SECTION 01 30 01
REQUEST FOR INTERPRETATION FORM
CONSENTINO MIDDLE SCHOOL - #21-0818

TO: Dore & Whittier Architects Inc. 260 Merrimac St., Bldg.7 Newburyport, MA 01950	FROM: Brait Builders	RFI #: RFI - 038
Attn: Tara King	Reply Requested by: Jake McDonough	Issue Date: 05/24/24
RFI DESCRIPTION (Indicate origin of RFI, and summarize the question or type of information required): Please see attached drainage clocks with constructibility issues. Please advise how to proceed.		
REFERENCES (List relevant Drawings or Specification sections and paragraphs): 		
SENDER'S RECOMMENDATION (All RFIs must include a contractor's recommended solution to each condition, including a statement of cost or schedule of impact if applicable. The contractor may be back-charged by the Owner for designer's review time for any RFI submitted without a sender's recommended solution or where response is evident in Drawings.) Nitsch Comment: Refer to comments below and ASI-11 for updates.		
DESIGNER'S RESPONSE:

RFI No.: JDC-03

Please see attached drainage clocks with constructibility issues. Please advise how to proceed.

Structure: D 226
Based On:
Job Name: CONSENTINO MIDDLE SCHOOL
Job Location:
Specification: 48" Storm
Contractor: DERENZO

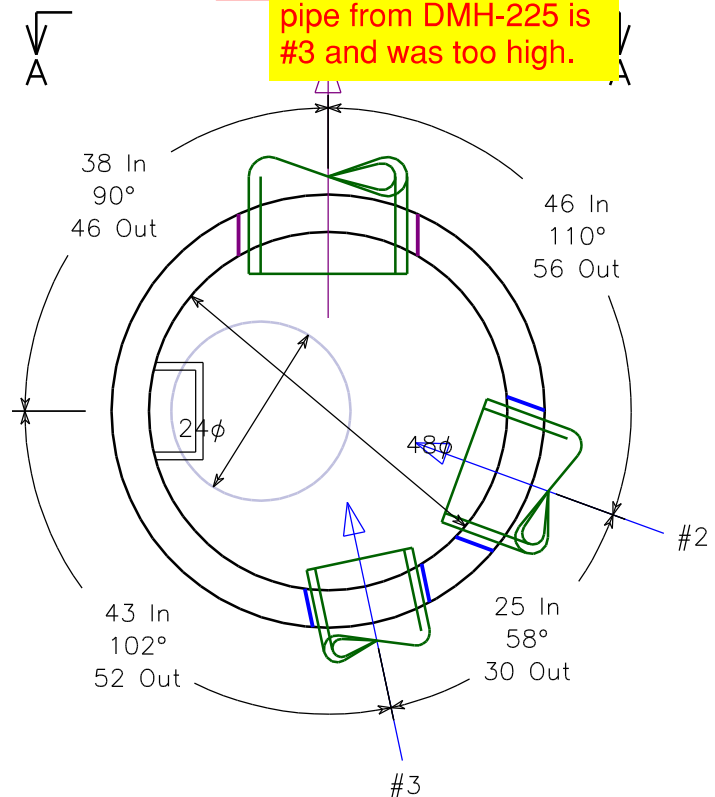
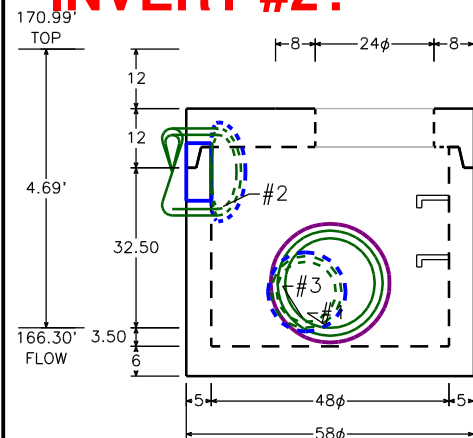
TOO SHALLOW
LOWER
INVERT #2?

Nitsch Response: Update
Inverts per ASI-11
